Salt Creek Park

Salt Creek Park is medium sized neighborhood park that provides parking, a playground, picnic areas with grills, barrier with restrooms and a drinking fountain. The main issues at this park are the need for accessible parking spaces in the gravel lot, slopes too steep, playground surface slopes, need for additional accessible picnic tables and grills and updating the restrooms. **Please Note:** When a **UD** is indicated, this is a Universal Design (**UD**) recommendation to enhance accessibility. The **UD** recommendation is not required to meet the minimum accessibility standards but it would be encouraged.

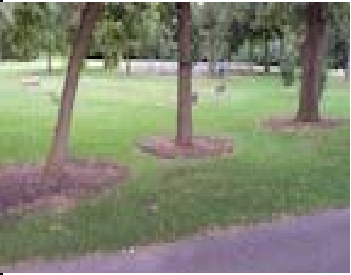
Photo	Barrier	ADAAG/IAC	Solution	Priority	By Whom	Projected Cost	Projected Date	Action Taken
	<p>There are 41 picnic tables provided under or next to the shelter, but only one is accessible.</p>	<p><u>Proposed</u> Outdoor Developed Areas Guidelines ADAAG 245 & 1011</p>	<p>Picnic Table Recommendation: At least 20% of picnic tables, or in this case 8 more tables be of accessible design, connected to an accessible route. Relocate or purchase eight accessible picnic tables and locate them on an accessible surface.</p>			\$1,650	2019	
	<p>A second set of picnic tables are in the grass and mulch and are off the route for 60'.</p>	<p>ADAAG 403.3</p>	<p>Provide a new accessible route with a running slope no steeper than 5% and a cross slope no steeper than 2% and a minimum clear width of 36".</p>			\$1,980	2019
